| DOCKETED | |
|-------------------------|---|
| Project Title: | 2022 Energy Code Update Rulemaking |
| Document Title: | Final Express Terms for the Proposed Revisions to the 2022 Energy Code Reference Appendices |
| Description: | ***This document supersedes TN # 240694*** |

Figure JA11-1: The Minimal Shading Criterion Artistic Depiction of "H" and "D"

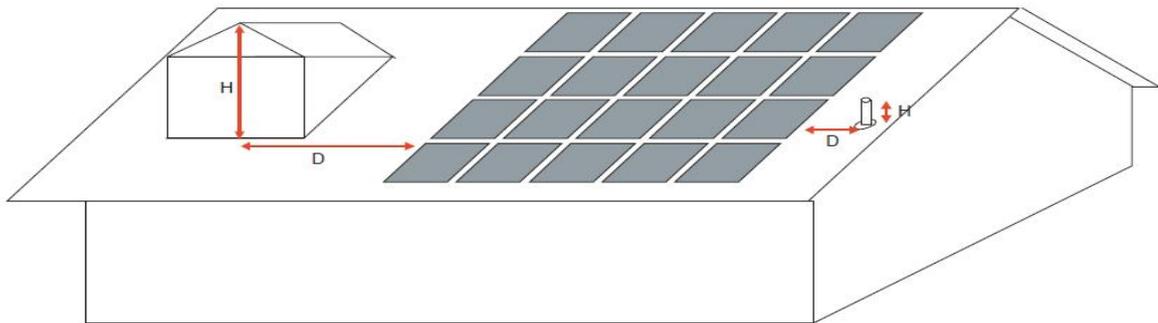
~~The minimal shading criterion is that no obstruction is closer than a distance (“D”) of twice the height (“H”) it extends above the PV array. (See Figure JA11-1 for an artistic depiction of “H” and “D.”) As Figure JA11-1 illustrates, the distance “D” must be at least two times greater than the distance “H.” All obstructions that project above the point on the array that is closest to the~~

Figure JA12-2: Example of Points Where Measurement Shall Be Made Using a Solar Assessment Tool

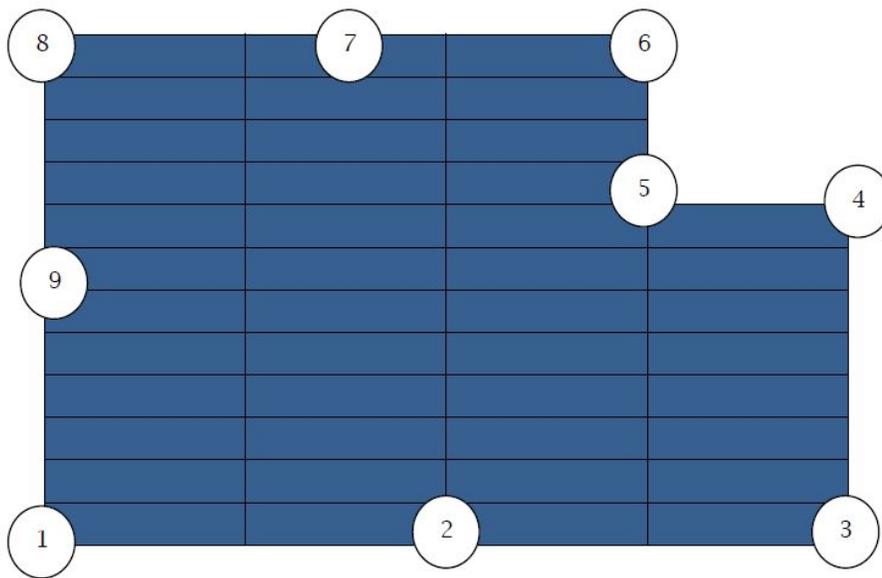
~~Measurements shall be made at all the major corners of the array with no adjacent measurement being more than 40 feet apart. (See example in Figure JA12-2.) The points of measurement shall be distributed evenly between two major corners if they are more than 40 feet apart such that the linear distance between any sequential points is no more than 40 feet. However, if any linear edge of the array has no obstructions that are closer than two times the height they project above the closest point on the array, then the intermediate measurements along that edge do not need to be made. Measurements made at each major corner and intermediate point shall be documented in the CF-2R Certificate of Installation.~~

Alternative Methods. Alternatively, for verification of solar access, the installer shall verify by an aerial satellite image(s), drone image(s), or other digital image(s) along with supporting documents showing the height of shading obstructions as well as the horizontal distance on the actual roof, and surrounding structures and trees, or by using an alternate method approved by the Executive Director to evaluate the solar access availability of the building location.
